City of Albuquerque

DESIGN HYDROLOGY SECTION
123 Central NW, Albuquerque, NM 87102
(505) 766-7644

RE: REVISED DRAINAGE PLAN FOR ZEPHYR CENTER
RECEIVED FEBRUARY 7, 1986 (L-22/D42)

RE: DRAINAGE PLAN FOR ZEPHYR CENTER
RECEIVED NOVEMBER 22, 1985 (L-22/D42)

SITE SUB-BASIN KEY

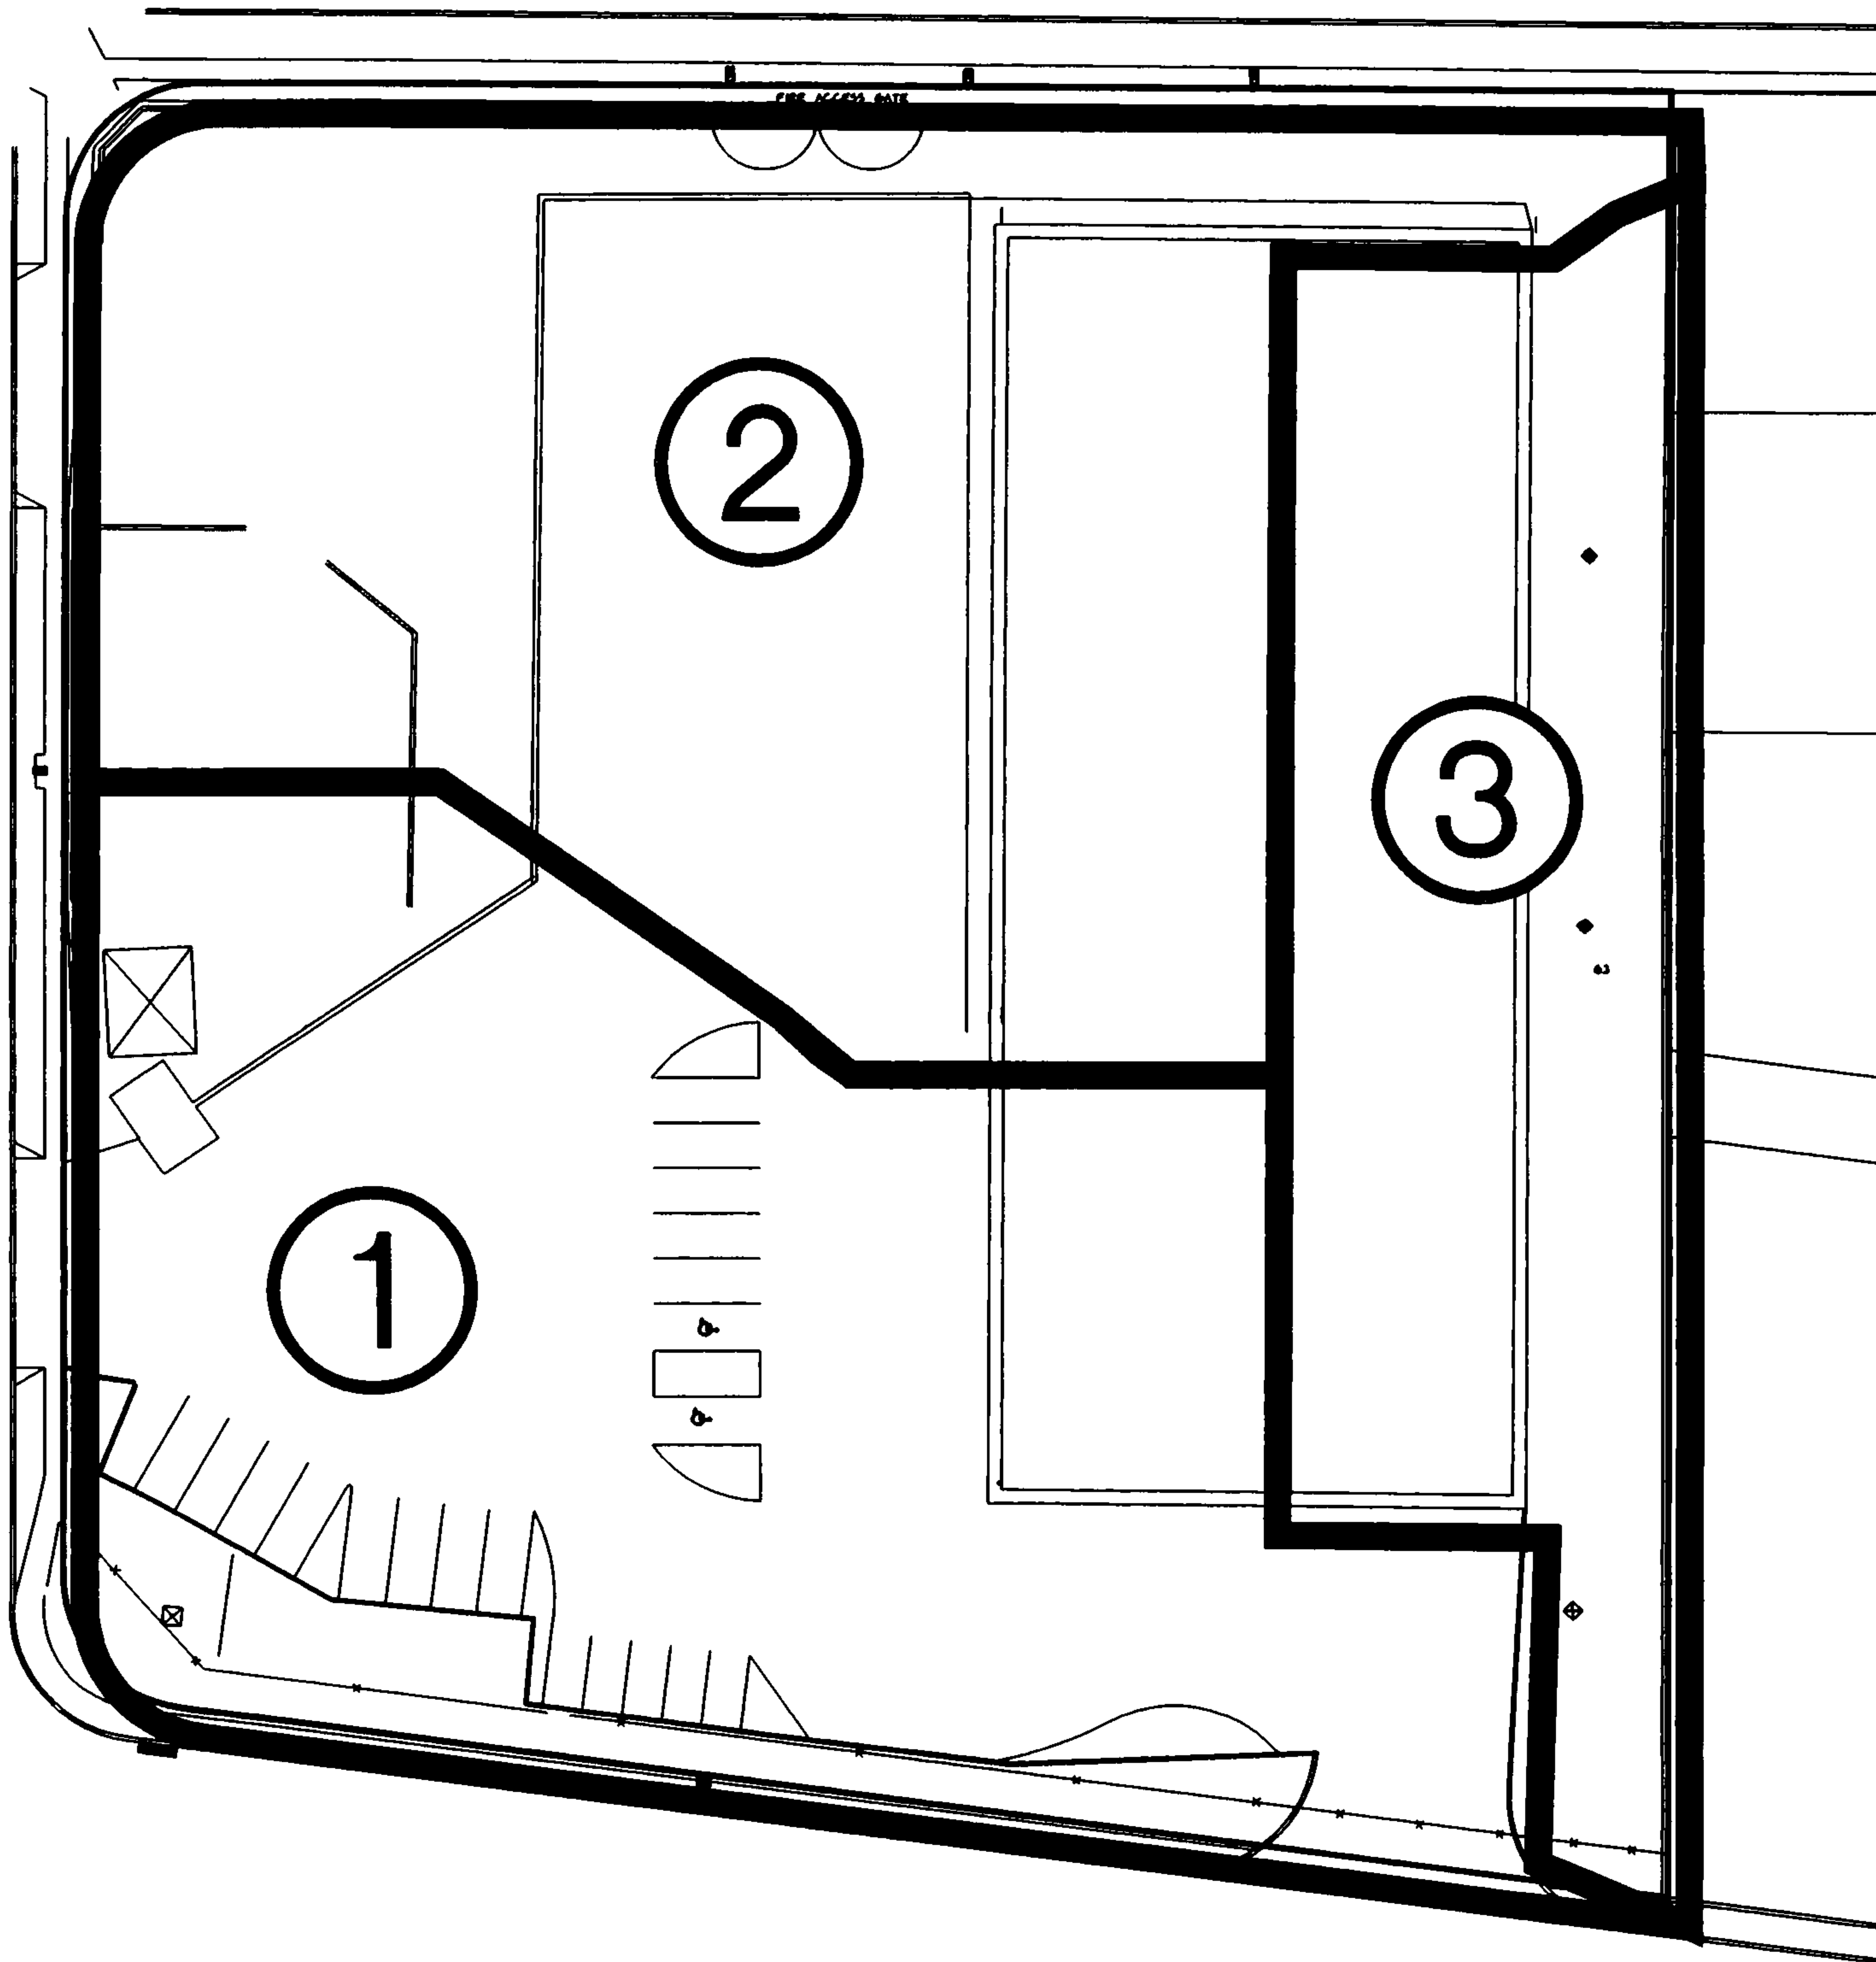
The flows to the Central Avenue storm drain system will increase by 1.2 cfs. This is an infill project in an area that is, for the most part, completely developed. The effect on downstream conditions by this increase will be insignificant.

CITY OF ALBUQUERQUE	
DRAINAGE	
DRAIN LINE CONNECTION	
TO EXIST. STORM INLET	
DWG. 2237	
AUG. 1986	
REVISIONS

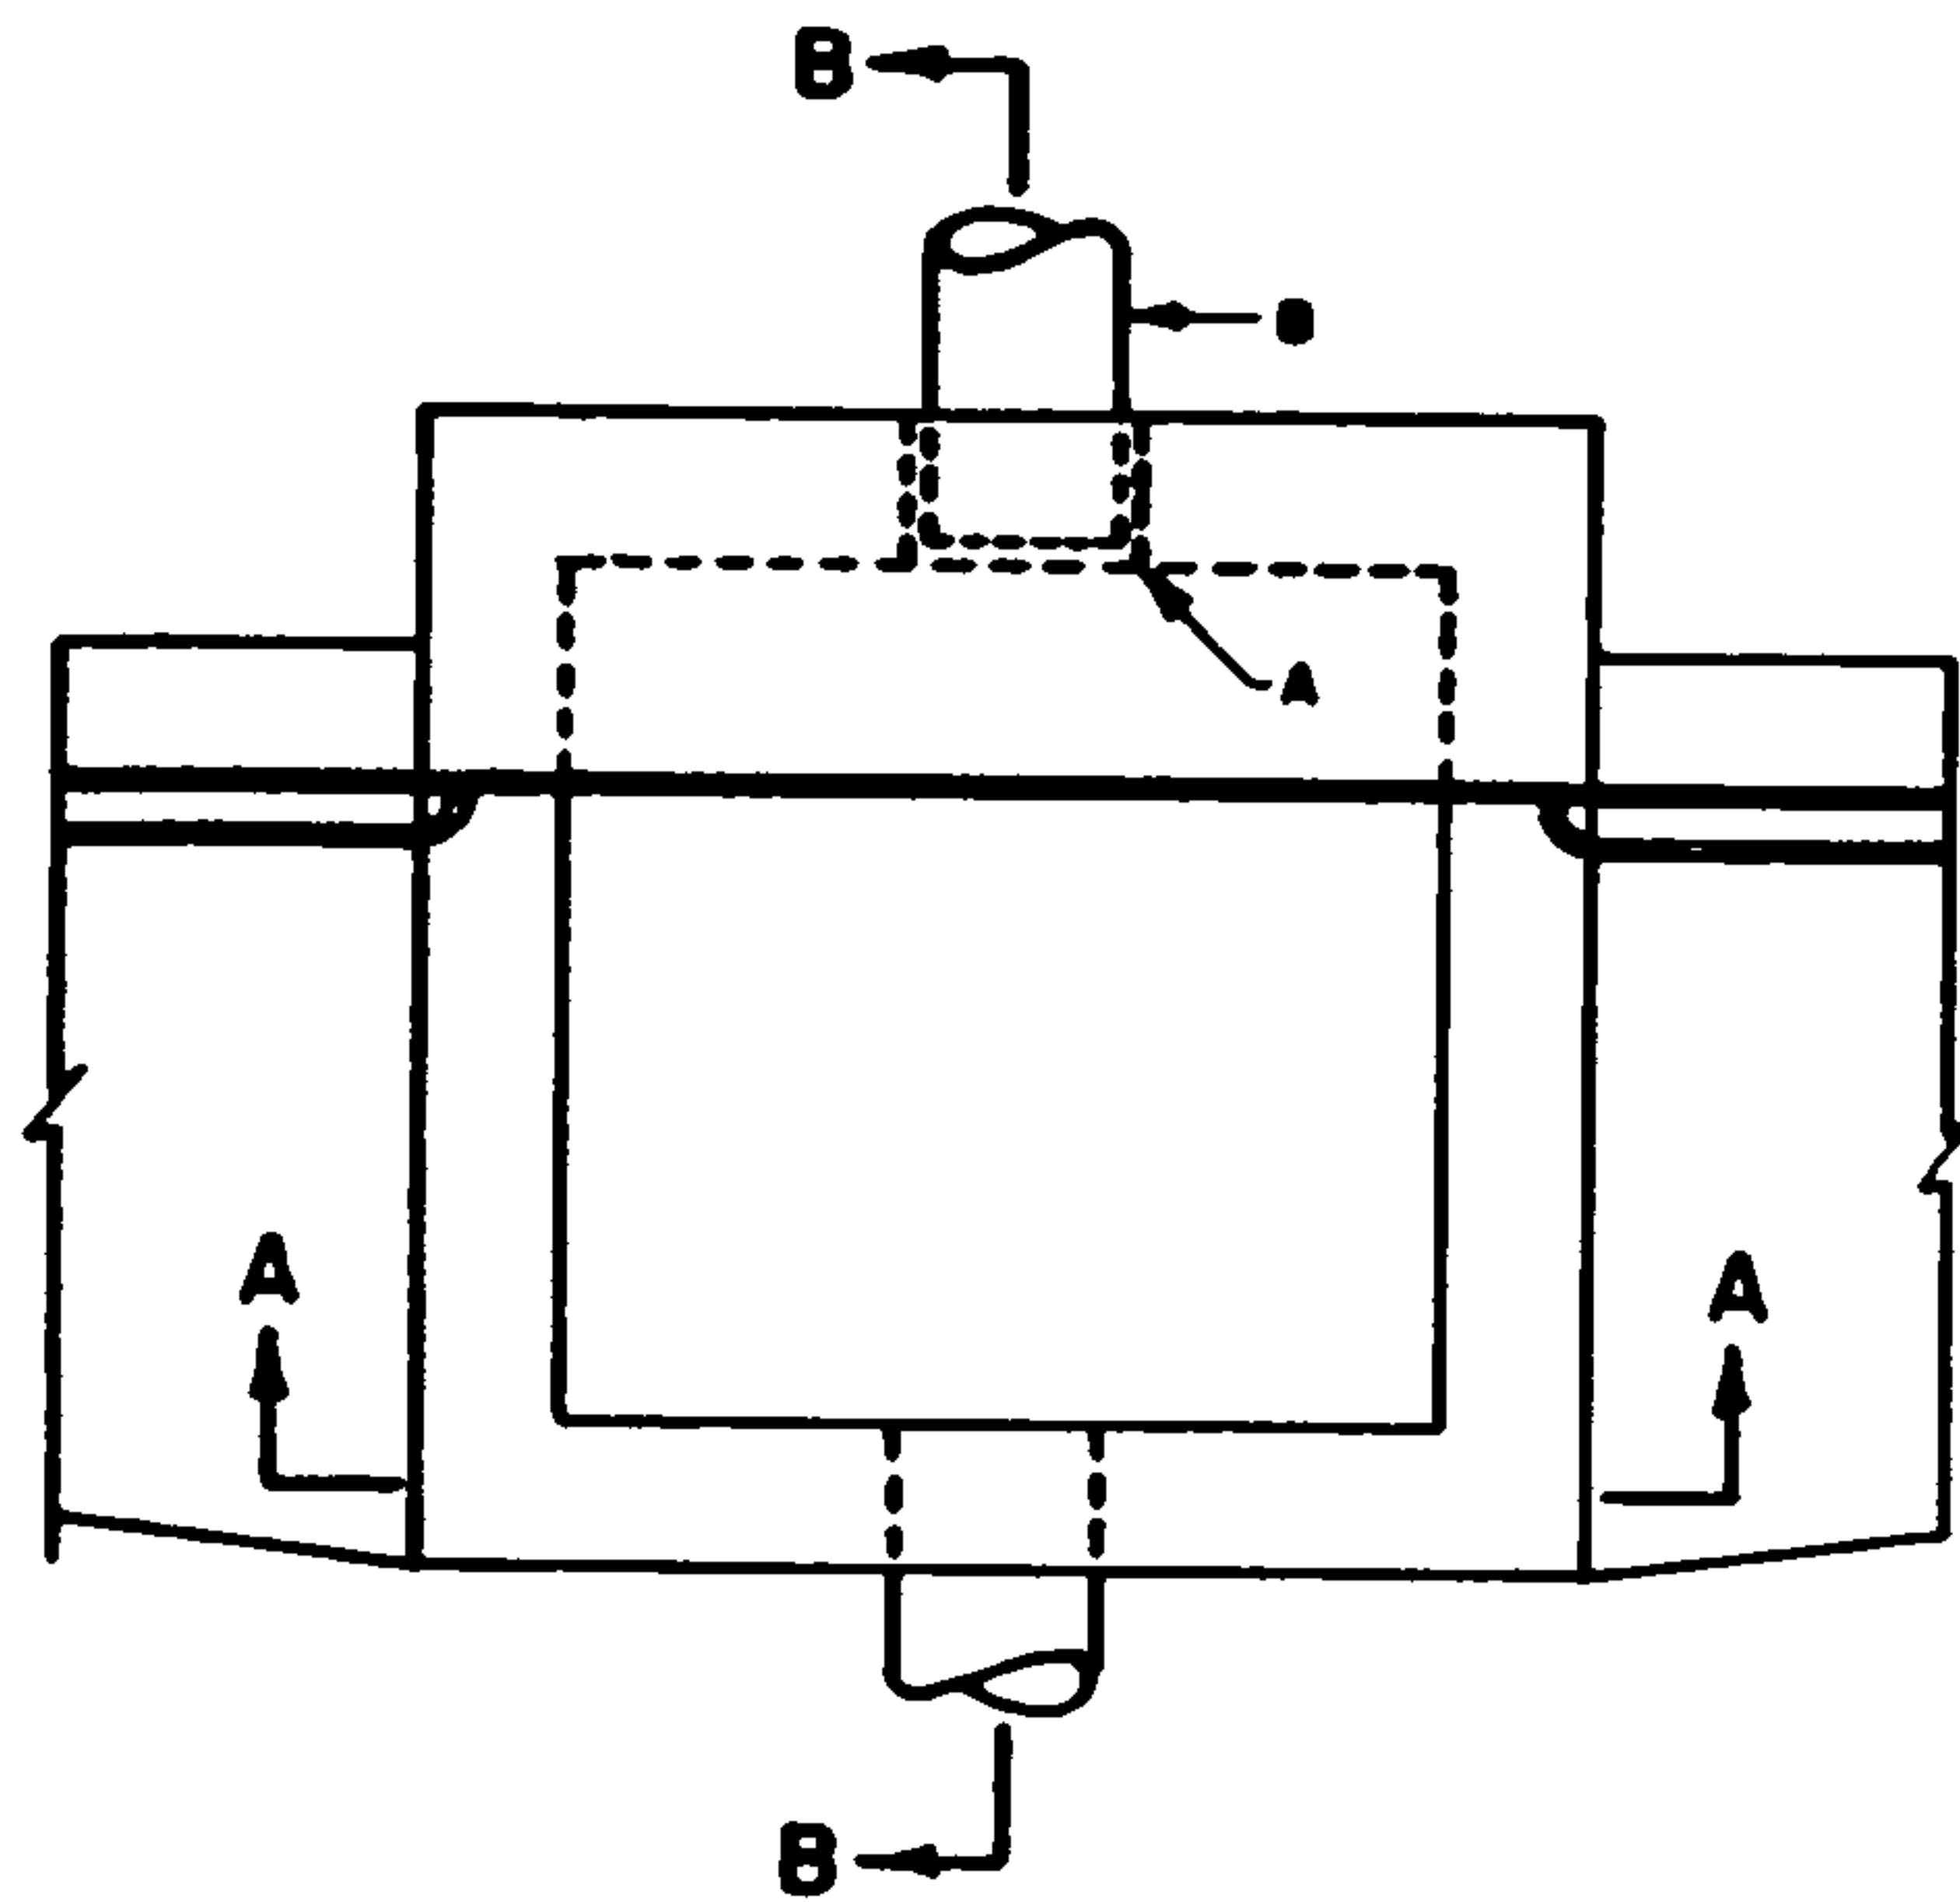
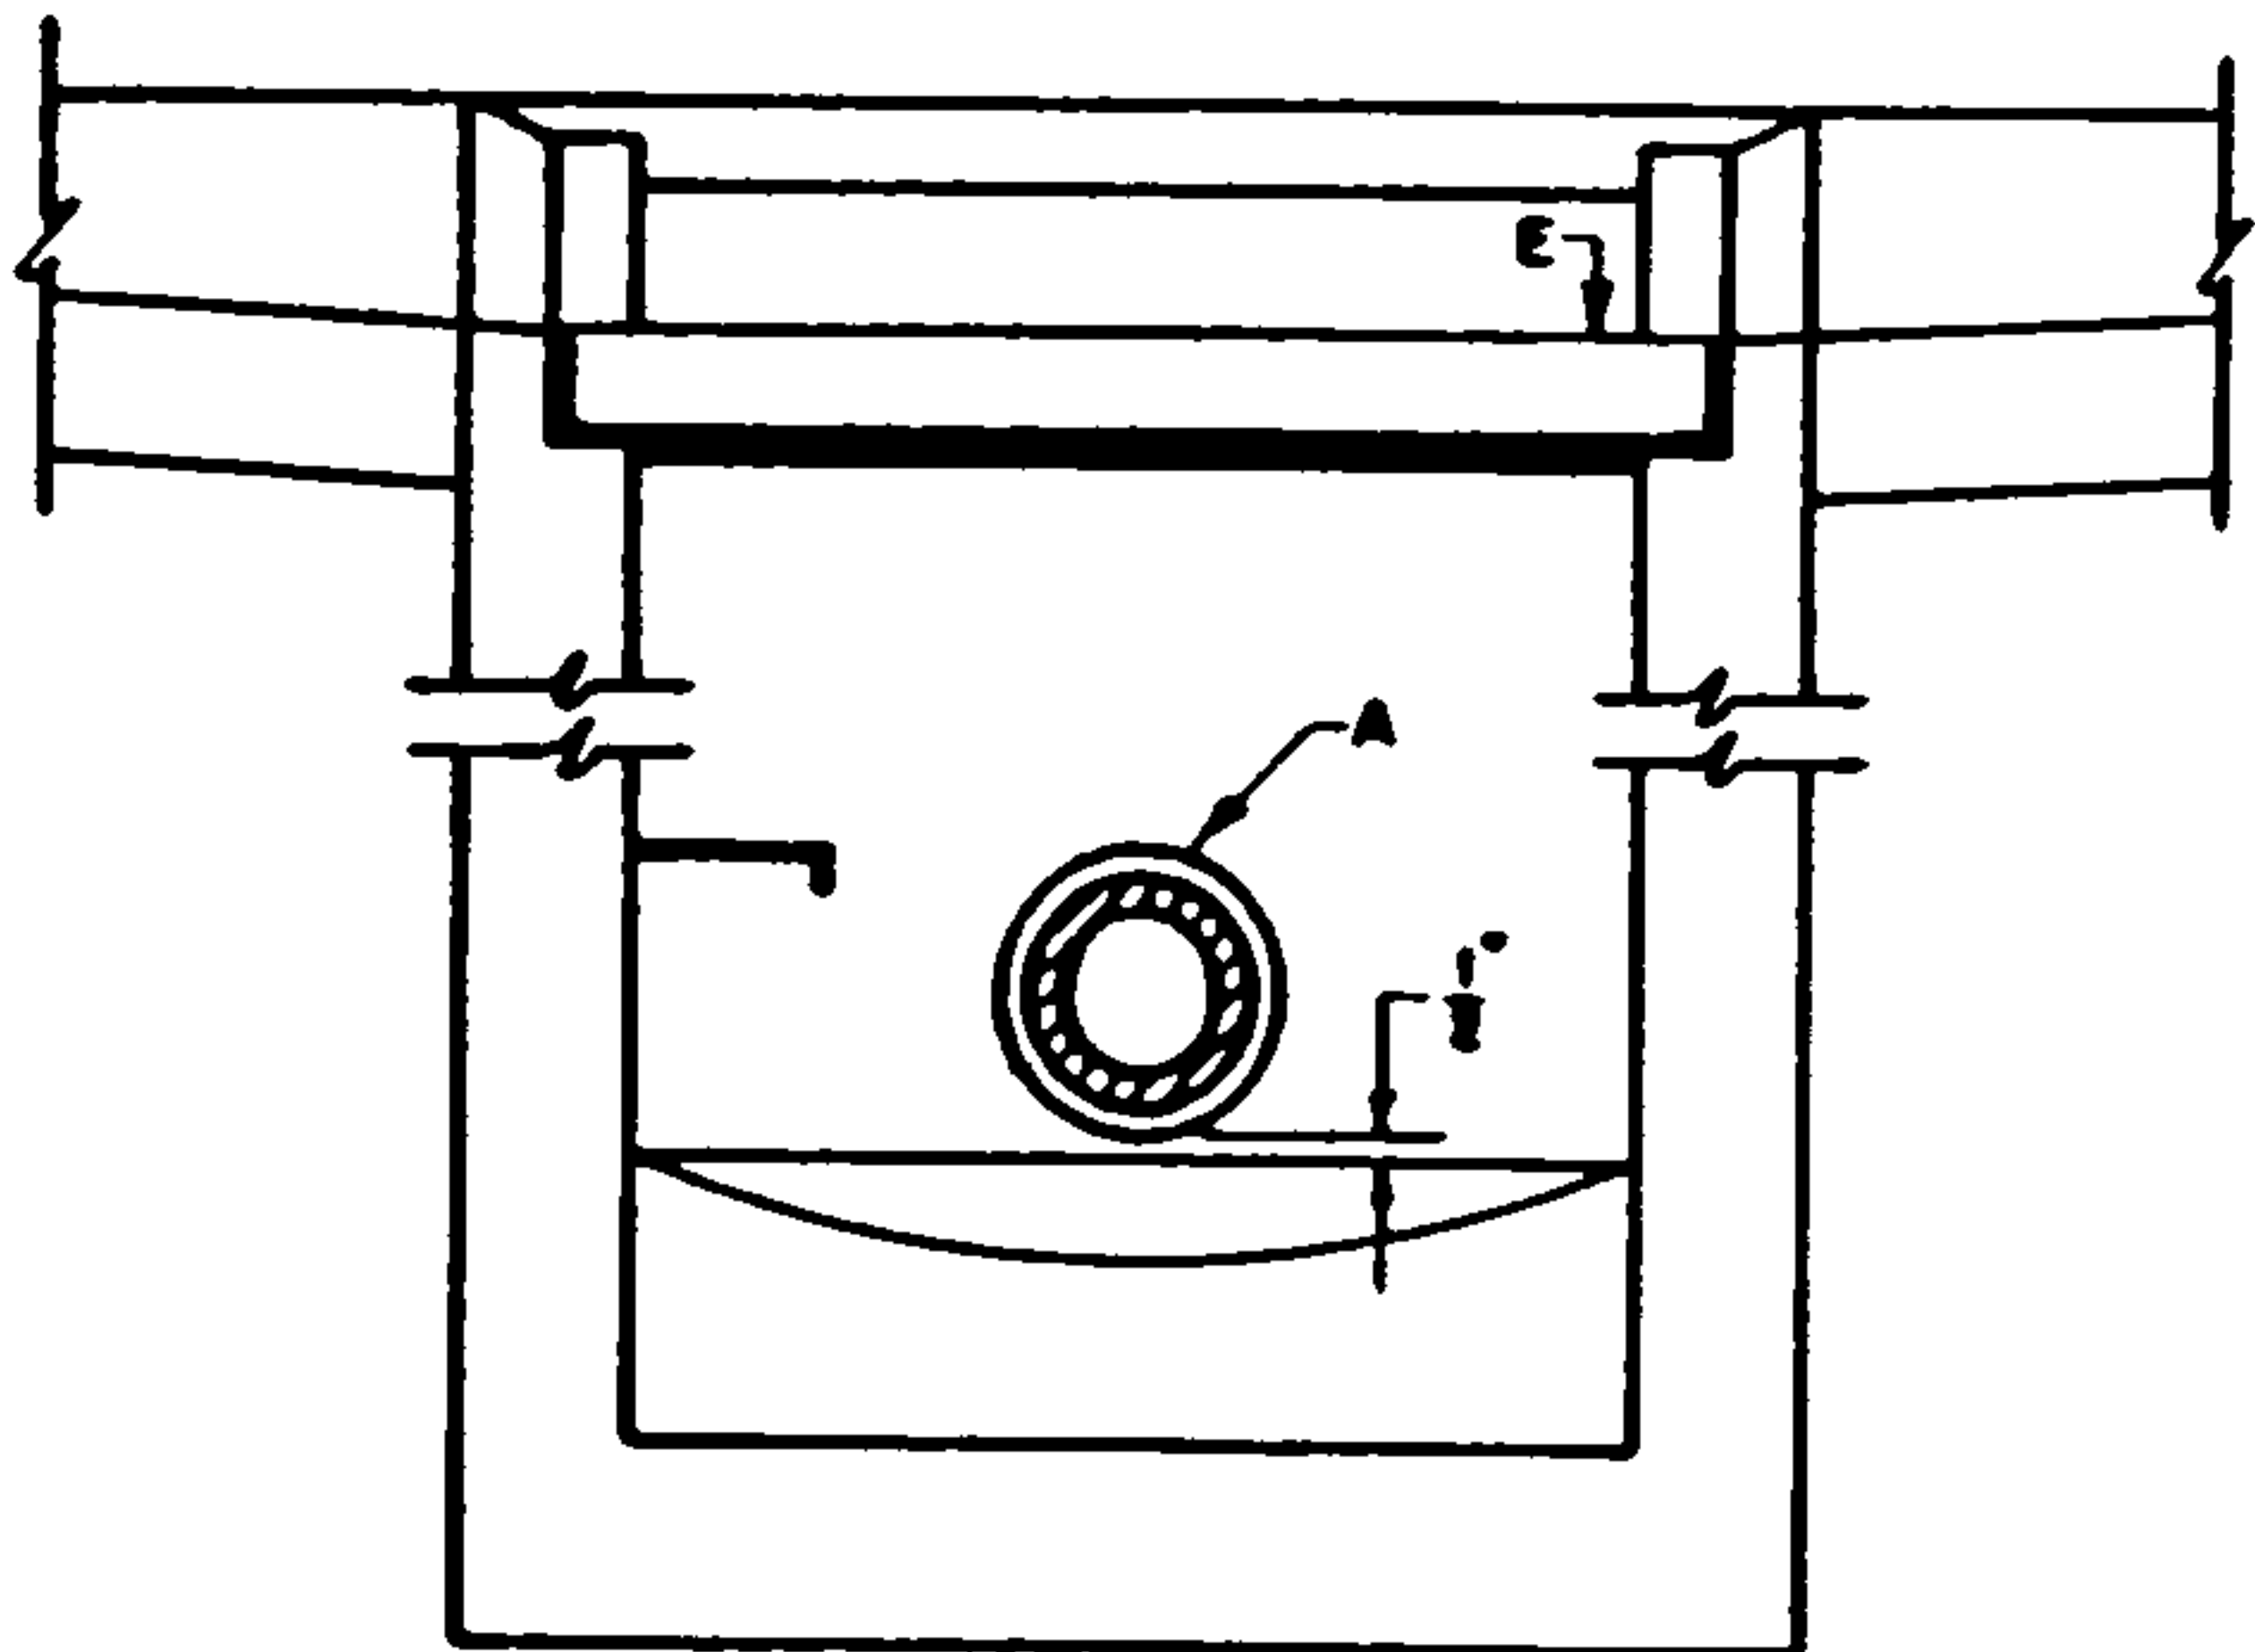
The maximum size pipe allowed for a drain line connection to an existing storm inlet is 12-inches (See DWG 2237 enclosed). This limitation, unfortunately, will negate the drainage plan which you have presented.

1. 24" diameter storm drain was based on a miscalculation. The correct size storm drain outlet to the existing Central Ave. inlet is actually 12" a minimum slope of 0.0200'/'.
 - Keyed note #13: *"install 36 lf 12" dia. PVC storm drain from new storm drain inlet to back of existing storm drain inlet within Central Blvd. Minimum slope = 2.0%. Contractor to field verify existing storm drain inlet flowline to and notify engineer if minimum slope cannot be met.*
 - Invert modified to accommodate minimum 2.0% slope.
 - Supplemental Calculations revised (highlighted in blue) as required.
